PN-EN 1998-3:2005/AC

**Eurokod 8: Projektowanie konstrukcji poddanych oddziaływaniom sejsmicznym --
Część 3: Ocena i rewaloryzacja budynków**

EN 1998-3:2005/AC

**Eurocode 8: Design of structures for earthquake resistance - Part 3:
Assessment and retrofitting of buildings**

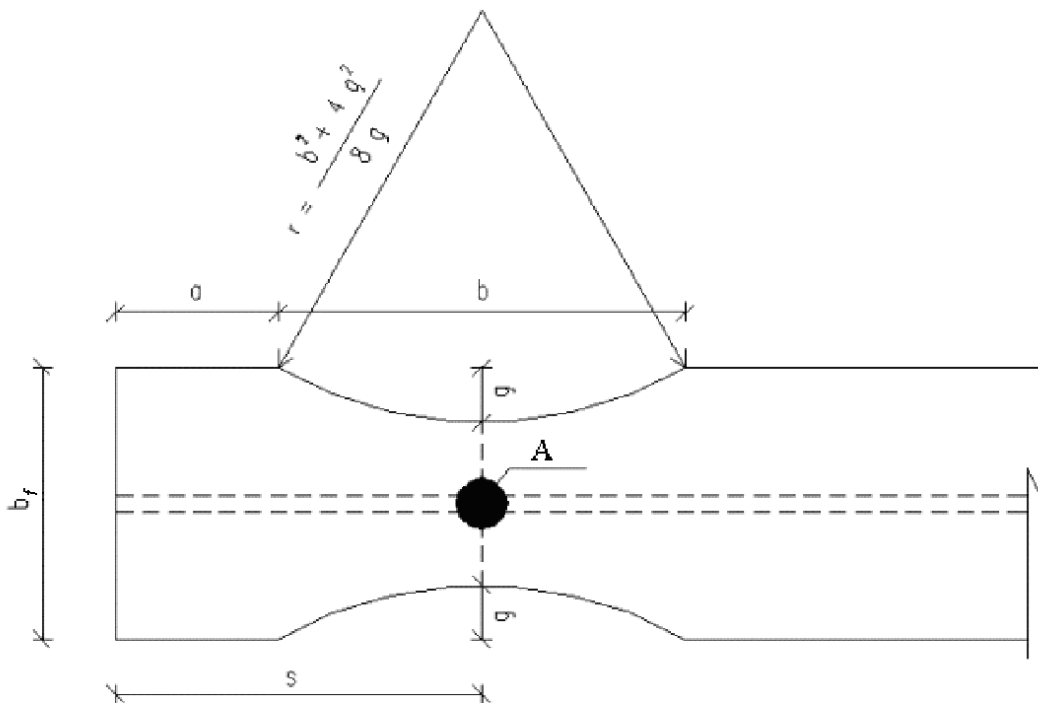
12) Modifications to B.5.3.4

Paragraph (3), subparagraph ii., Figure B.1, replace the figure with the following one:

Paragraph (3), subparagraph vii., replace "cut-depth c and repeat steps (iv) to (vi). The length g should be" with "cut-depth g and repeat steps (iv) to (vi). The length b should be".
